AGENDA
BIRMINGHAM DESIGN REVIEW BOARD
WEDNESDAY MARCH 1, 2023
BIRMINGHAM CITY HALL, 151 MARTIN ST, COMMISSION ROOM 205, BIRMINGHAM MI *
******* 7:15 PM*******

DATE: March 1, 2023
TO: Design Review Board
FROM: Nicholas Dupuis, Planning Director
SUBJECT: 185 Oakland – Design Review

185 OAKLAND OFFICE RENOVATION

DATE: March 1, 2023
TO: Design Review Board
FROM: Nicholas Dupuis, Planning Director
SUBJECT: 33680 Woodward – Petrucci Studio – Design Review

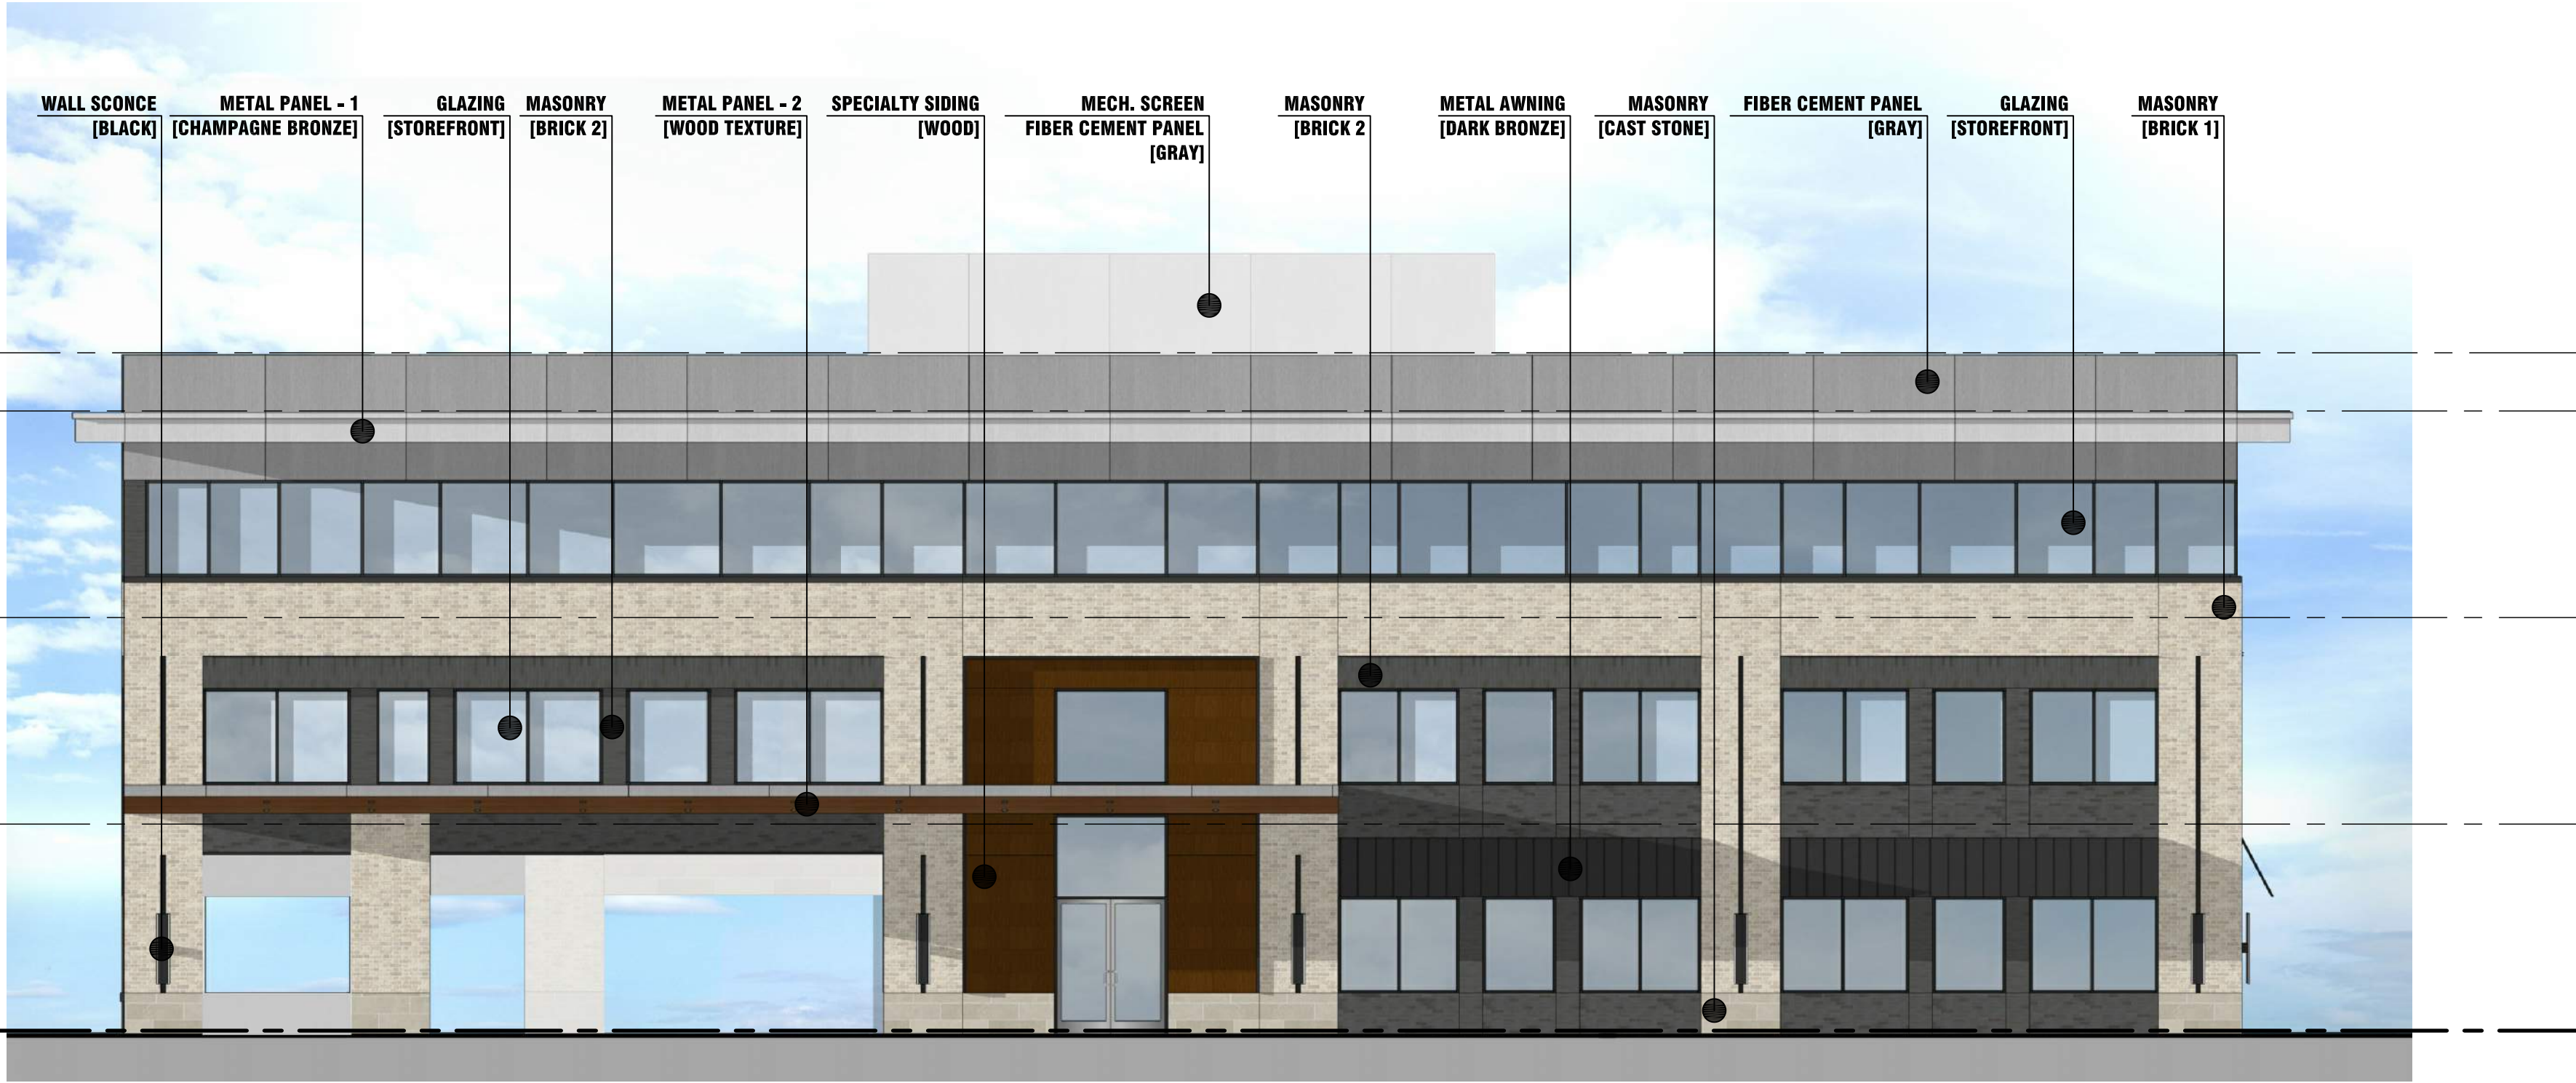
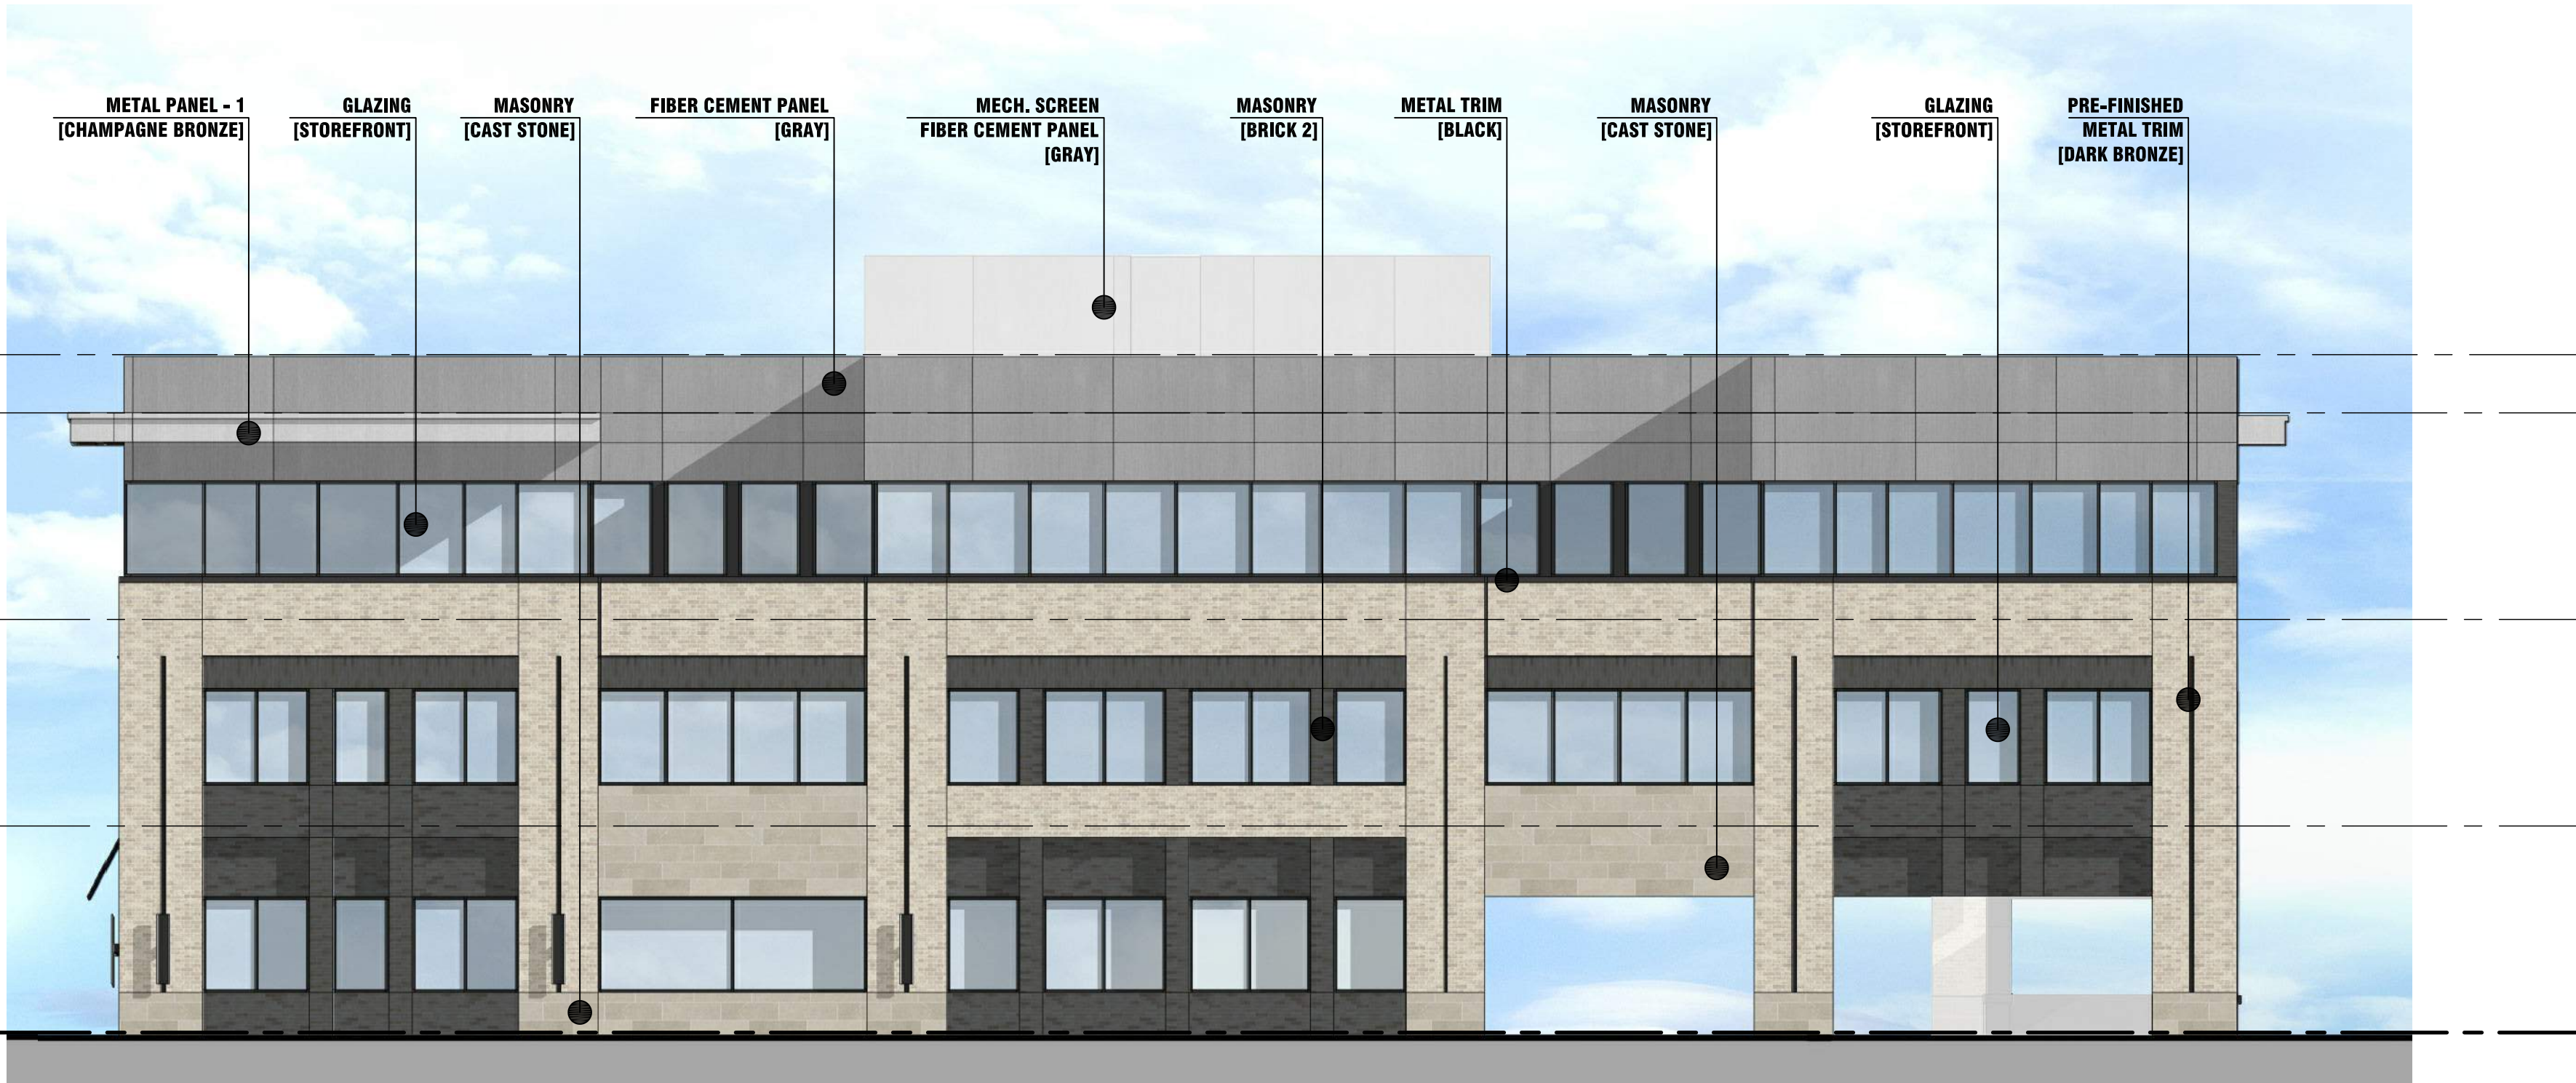
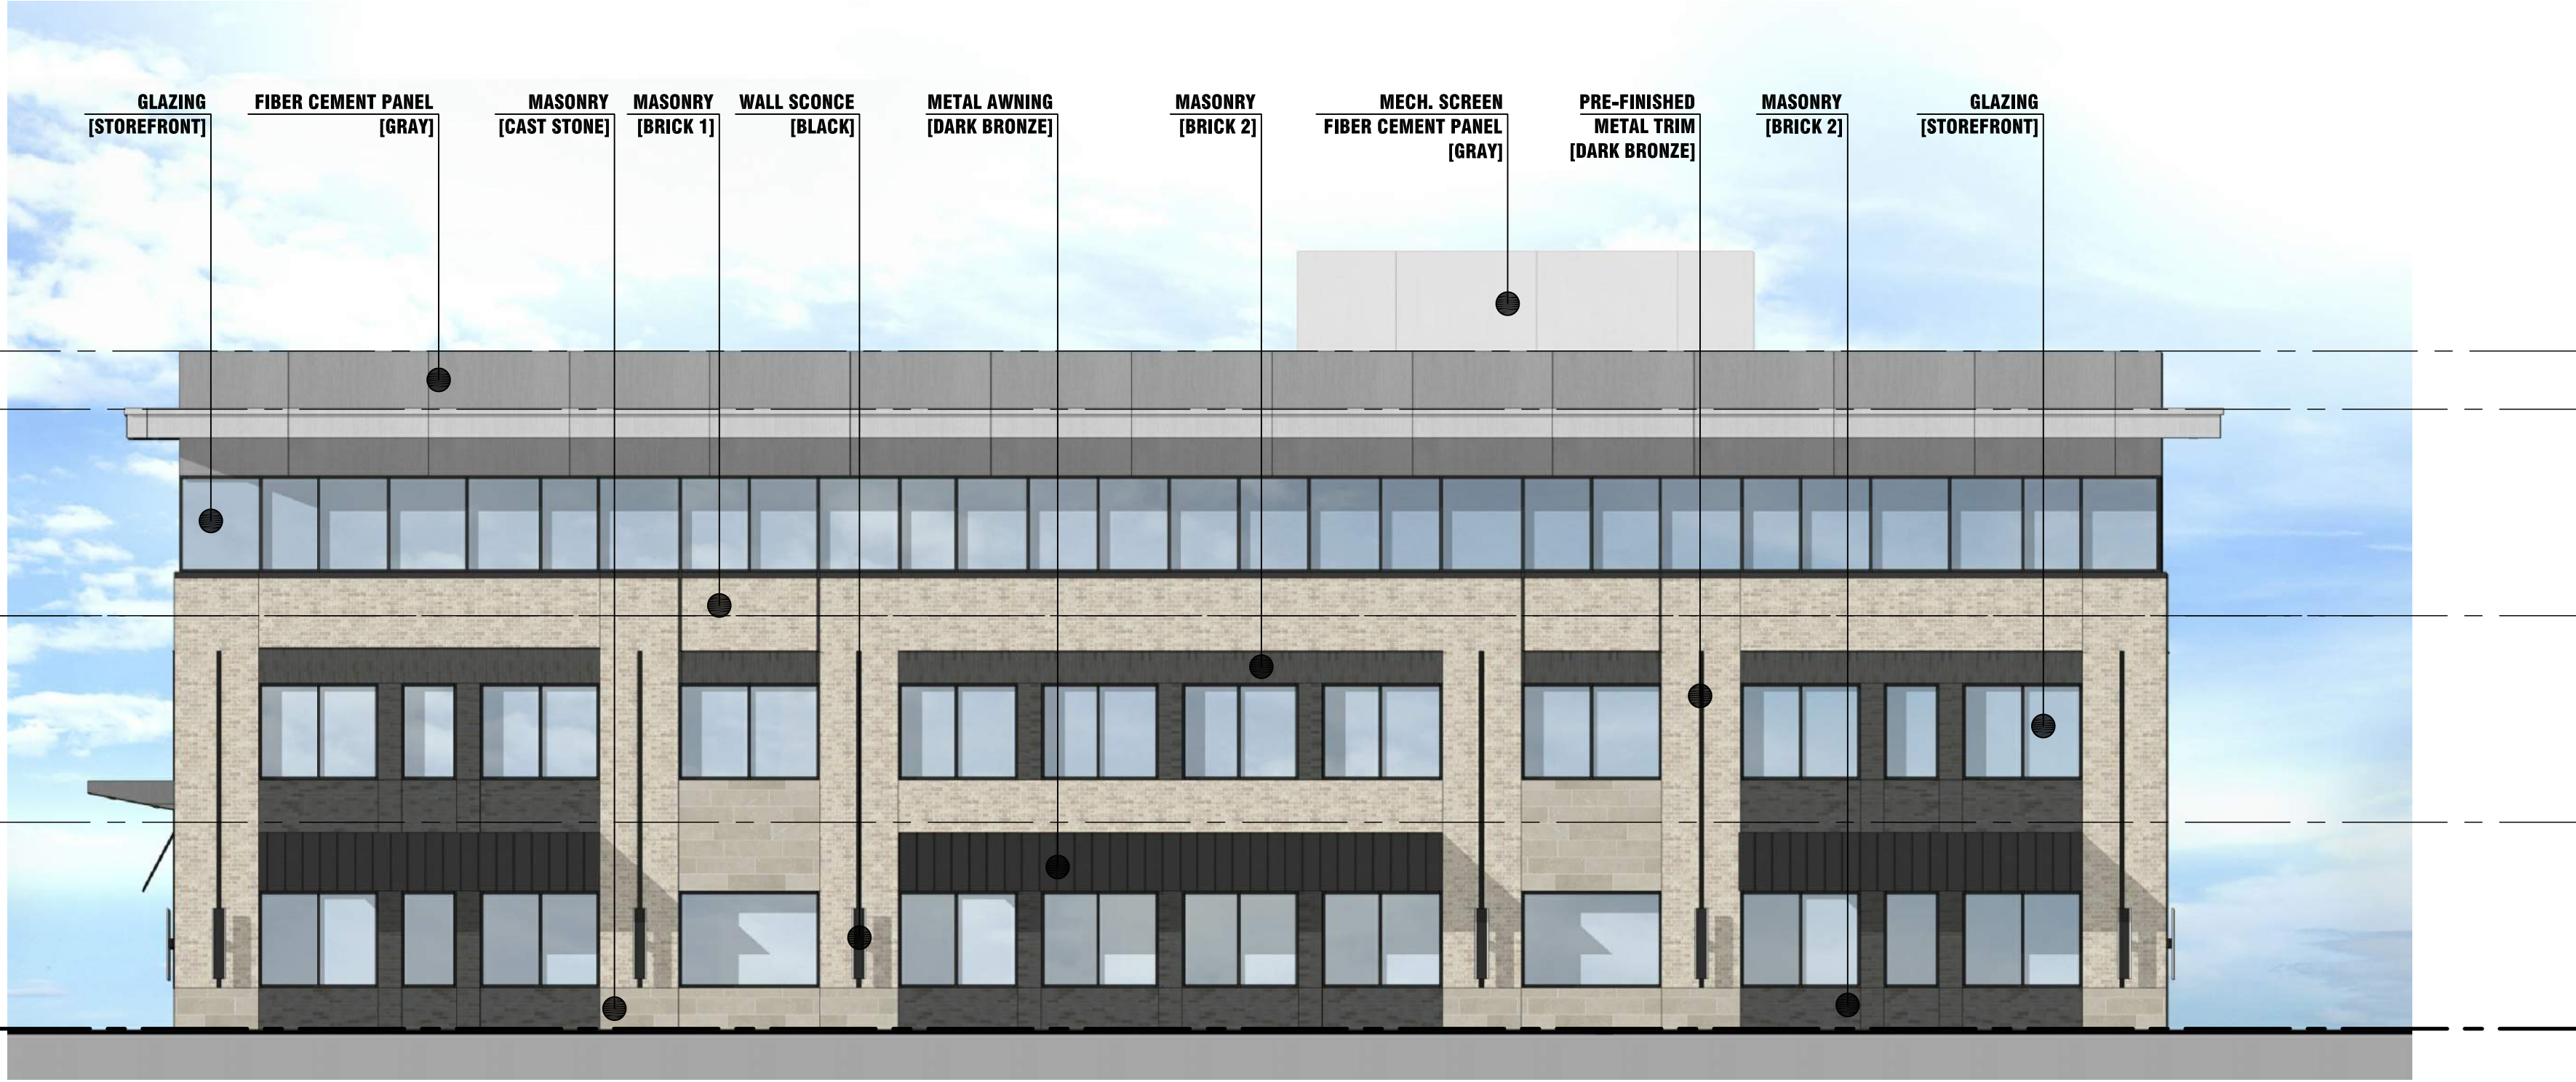
The applicant has submitted glazing calculations for the South and West facades of the building. The proposed south façade measures 41% and 25% on the first and upper floors, respectively. The proposed west façade measures 53% and 24% on the first and upper floors, respectively. **The proposed glazing on the first floor façade in between 1 ft. and 8 ft. does not meet the 70% glazing requirement.**

Thus, **the applicant must submit revised design plans demonstrating transparent areas equal to 70% of its portion of the facade, between one and eight feet from the ground on the south and west facades, or obtain a variance from the Board of Zoning Appeals. Additionally, the applicant must submit glazing specification sheets to ensure the clarity requirements are met.**

Sheet
A202

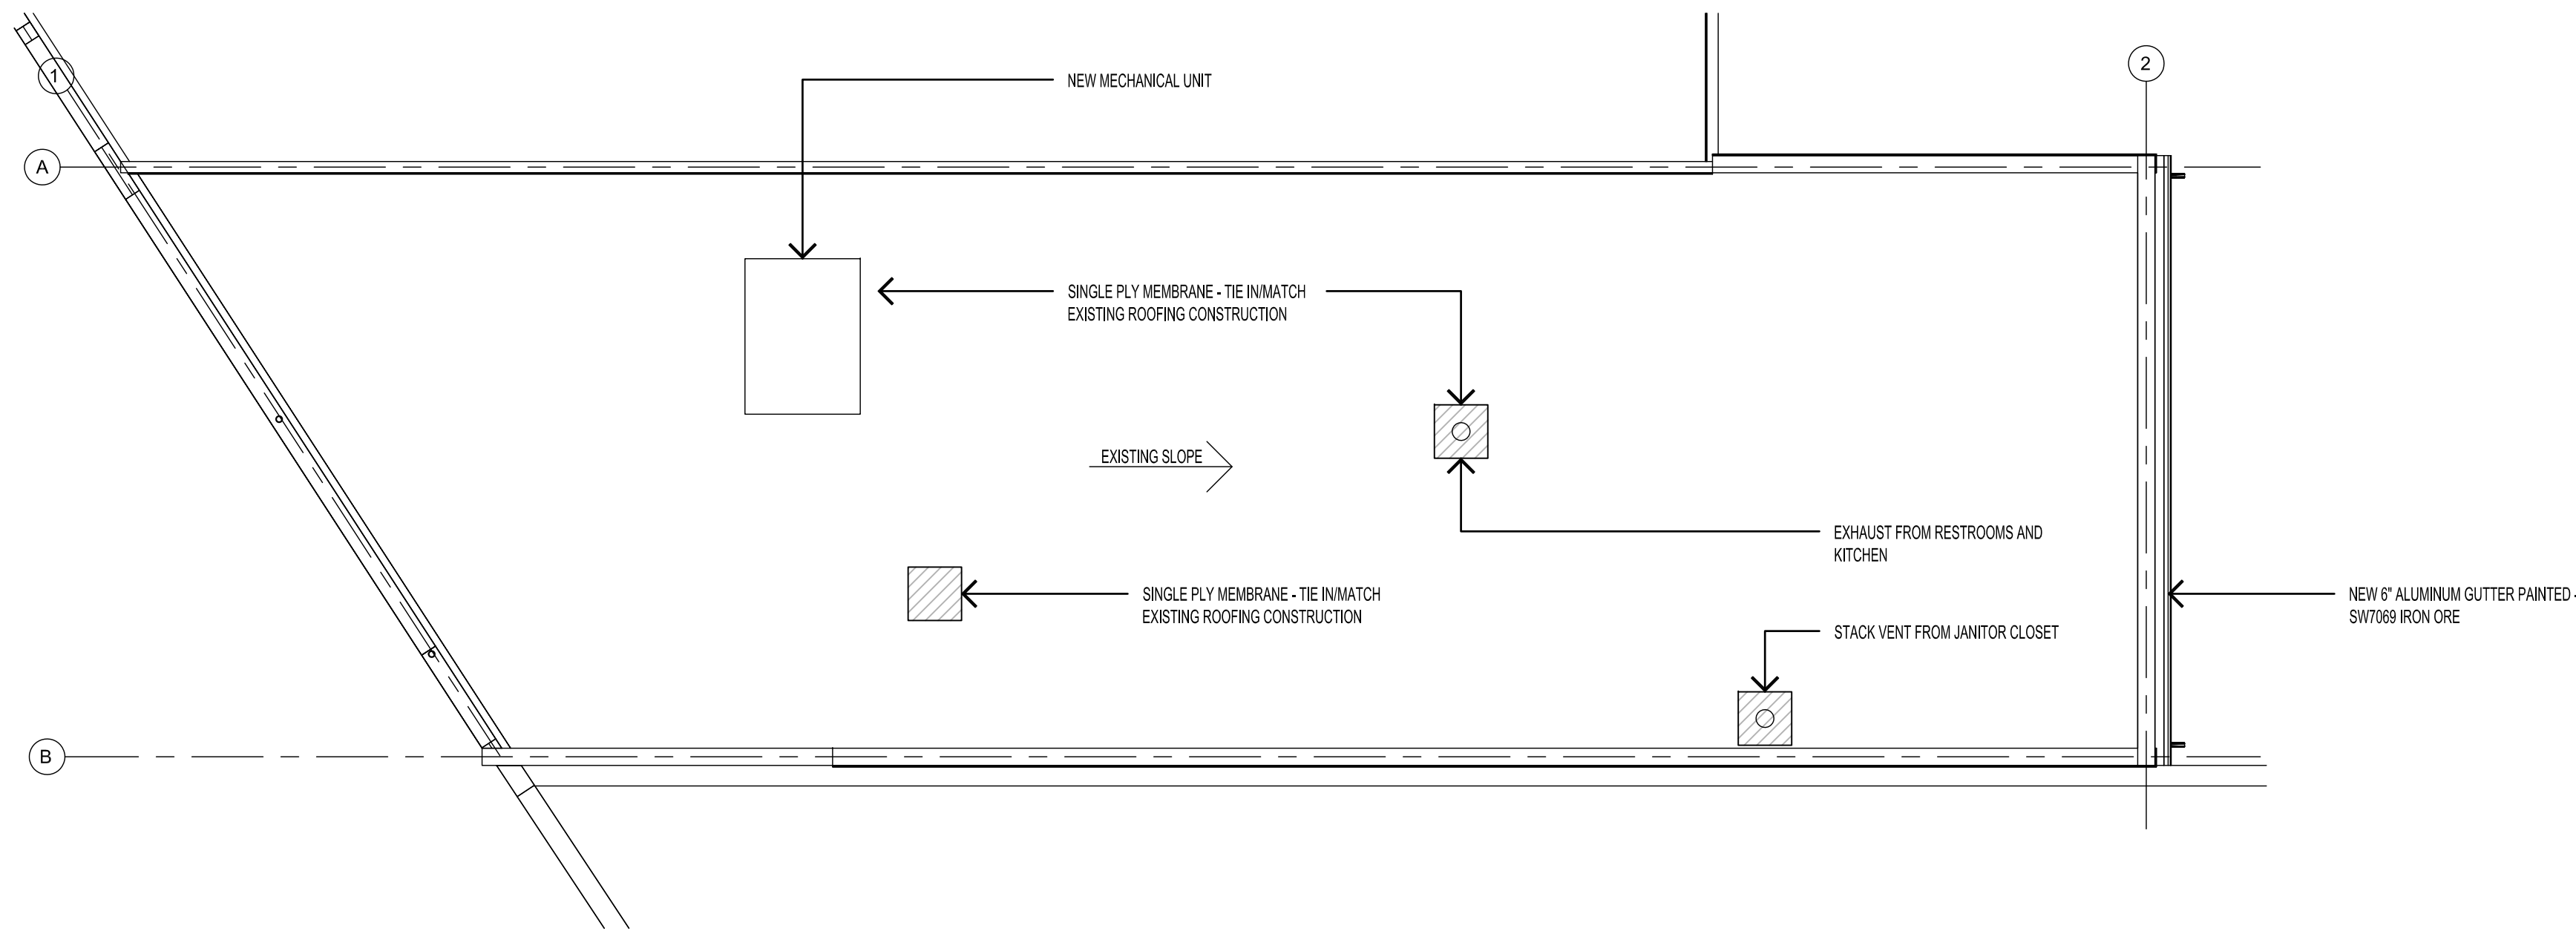
- Building Use – The proposed use as a showroom and office for Petrucci Studio is permitted.
- Screening – Sheet A202 of the site/design plans submitted indicate a new RTU towards the west side of the roof. It does not appear that the unit will be screened in accordance with Article 4, Section 4.54 of the Zoning Ordinance. In addition, the applicant has not submitted any specification sheets for the proposed units. **Thus, the applicant must submit revised site/design plans and specification sheets that include screening and details for the new proposed RTU.**
